RESPONSE TO DEP EMAIL OF APRIL 27, 2010

BWP-SW-21 / Transmittal # X232995

April 29, 2010

*Figure 2 - New CD Dropoff Area
Permit Application
BWP-SW-21
New CD Area*

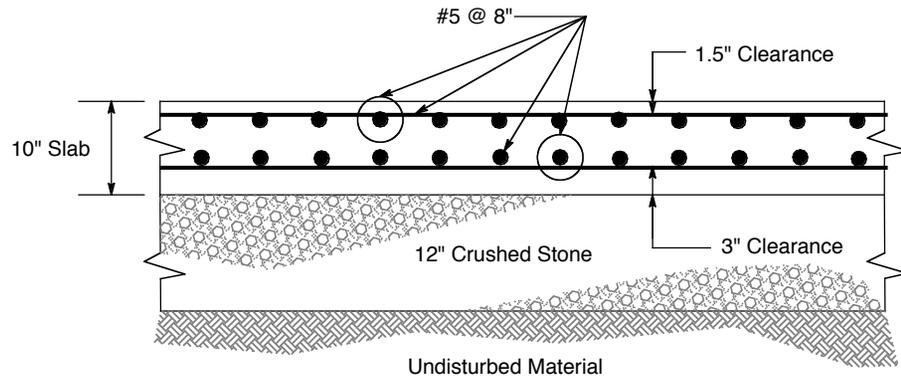
A question was also asked about the grade differential at the proposed new C&D area and separation of work flow areas from customer flow areas. Figure 2 has been revised to clarify how the new facility would function.

Existing construction and demolition dropoff area to be replaced. Open topped trailers will be positioned here for use by staff.

Figure 4
BWP-SW-21 / X232995

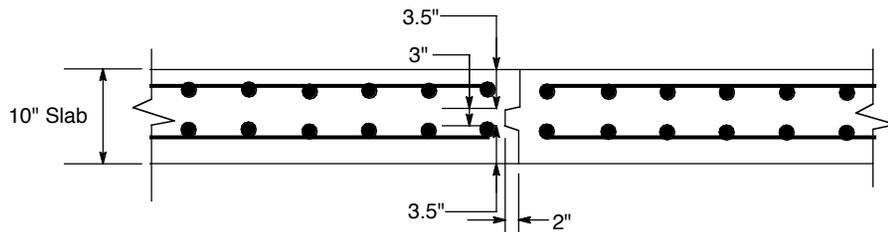
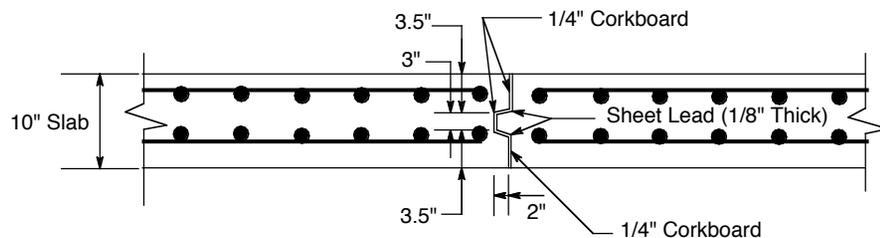
- 1) Is Ms. Vanderhoef still the correct contact and direct recipient for the permit or should Neil Andres be used?
- 2) Please provide a cross section sketch of the slab thickness and reinforcing.

1. Ms. Vanderhoef should be the direct recipient for the permit.
2. See Figure 4, attached, for a slab cross section and other details.
3. See Figure 5, attached, for details on the block wall construction.
4. The existing emergency generator receptacle is a standard receptacle located by door of scalehouse. No new wiring is required internally or externally to enable hookup, including no new conduits below grade.

Figure 5
BWP-SW-21 / X232995
A T P ENVIRONMENTAL
April 29, 2010

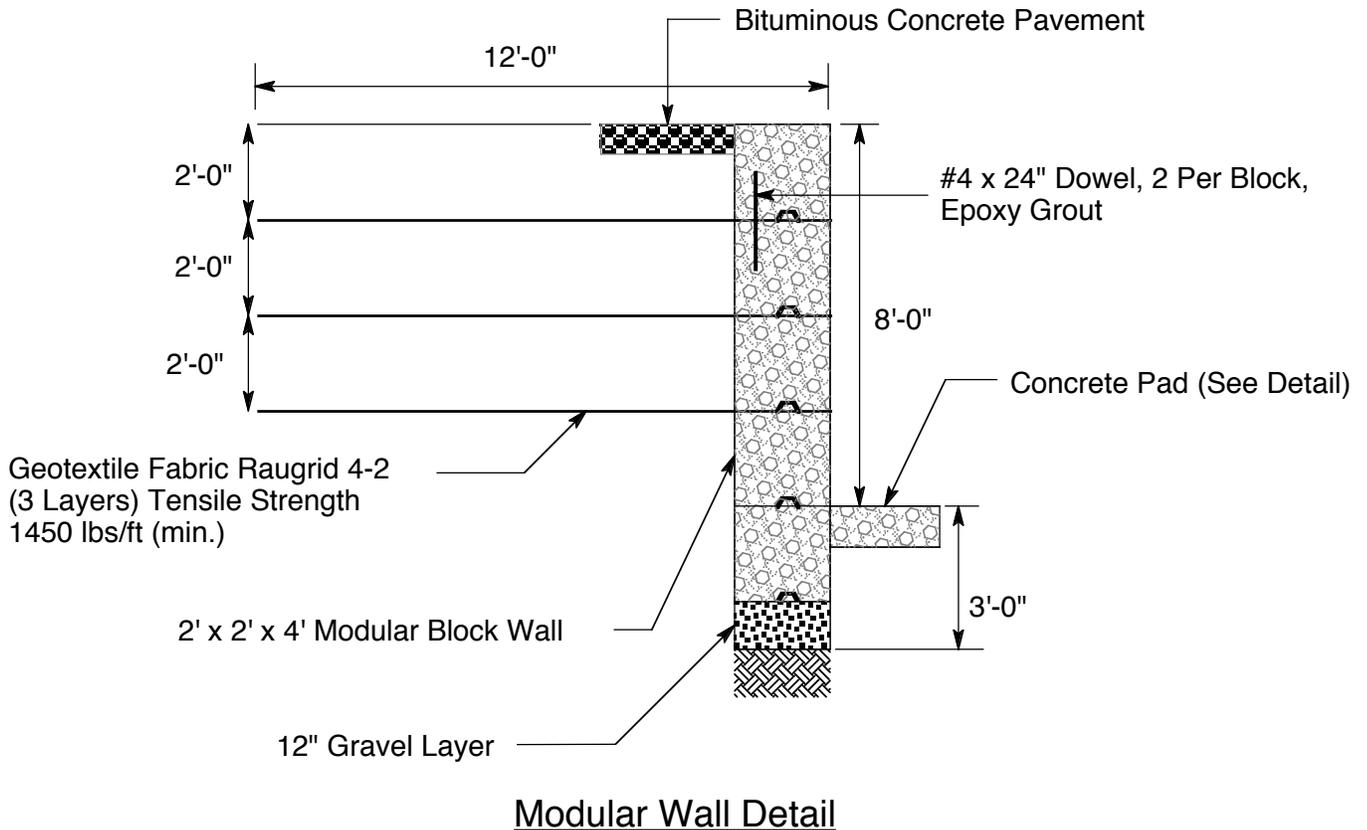
- 3) Please provide details on the block wall construction. A cross section showing maximum height and construction materials and any tie back reinforcing should be submitted. I do not need stability calculations but the drawing should be stamped by a PE to show that it is designed by an engineer.
